Re: FCC ID LOZ102036

Aironet Wireless Communications Inc

LOZ102036 – Additional Information

Line Conducted

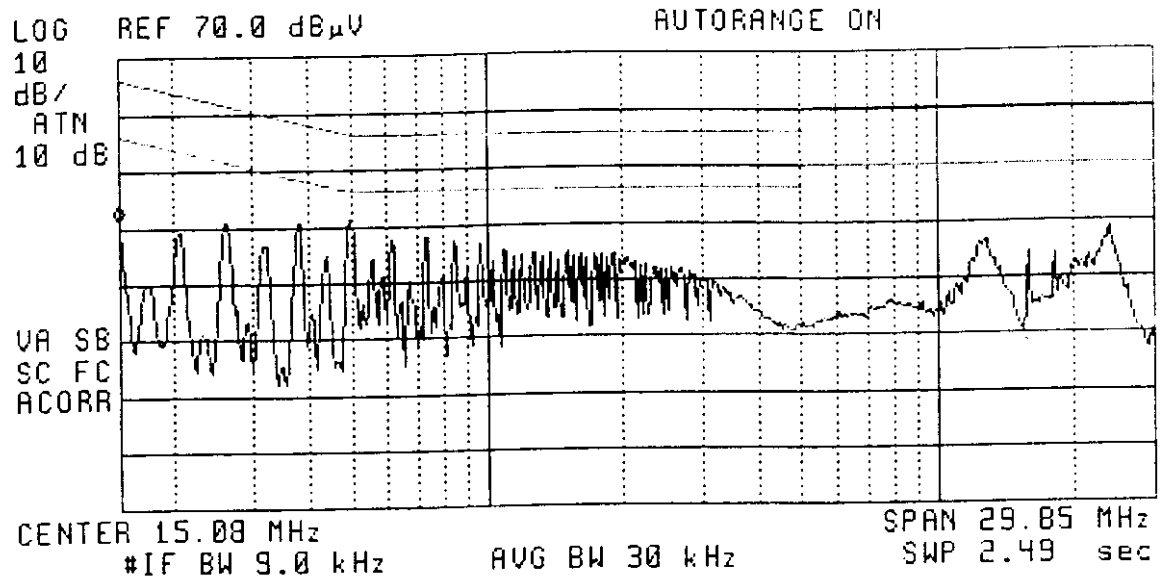
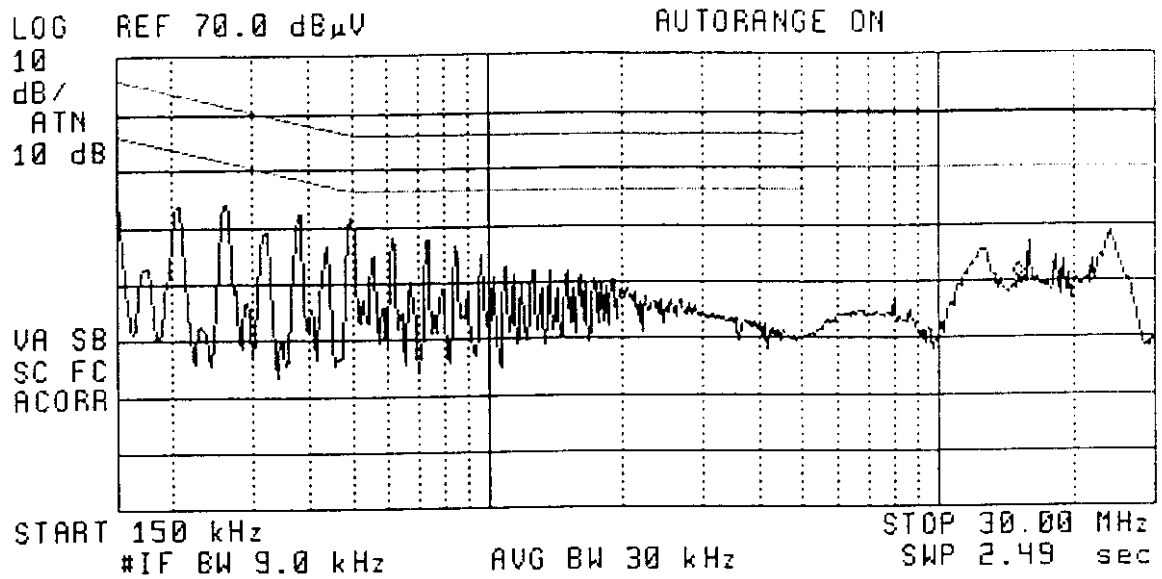
- ✓ 5) Submit line conducted test data.
- ✓ 6) Indicate the type of antenna connector and antenna cable connectors and why they are unique.
- ✓ 7) The system shall hop to channel frequencies that are selected at the system hopping rate from a pseudorandomly ordered list of hopping frequencies. Indicate how the pseudorandom hopping sequence is derived. Provide a list of channel frequencies and a sample of a few sequences.

- 4) See attached explanation from LM3100 – the PCMCIA version of this radio that is currently pending approval at the FCC.
- 5) Line conducted data attached

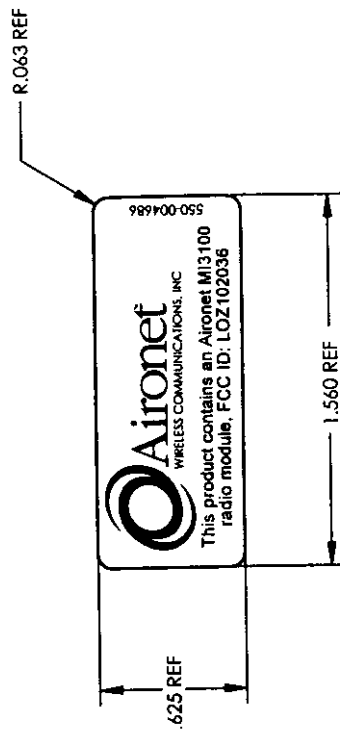
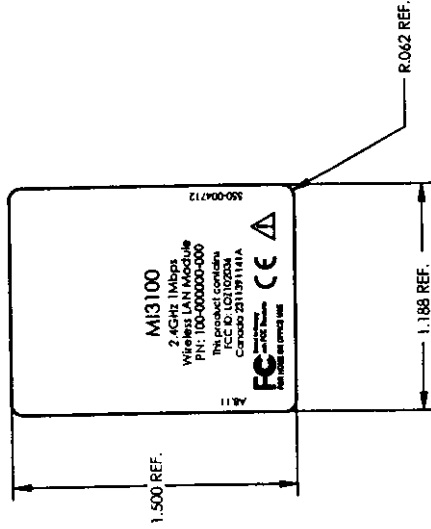
- ✓ 3) The device is composite device consisting of a transmitter and a computer peripheral. Indicate whether the computer portion is a DOC approved or will be Certified. If it is DOC approved the label will have to be corrected and the DOC Certificate submitted. If it is to be Certified, submit an additional fee and test report for the computer peripheral portion (test must meet the minimum test configuration). If the device is strictly Class A, neither of the above applies.

- 10) See number 8 for explanation. Maximum dwell time is 400 microseconds per FCC Part 15.247.
- 11) Transmitter module : The PC card that the radio is installed on has no voltage regulation, clocks, or buffering on board. The PC card only has the PCMCIA controller and memory, all intelligence is programmed into the radio. The radio has it's own shielding, on board voltage regulation (where required), data buffers, and unique antenna connector per 15.203. We are providing a label for the customer to apply to the outside of his unit which will state : This device contains Aironet Radio module FCC ID: LOZ102036.
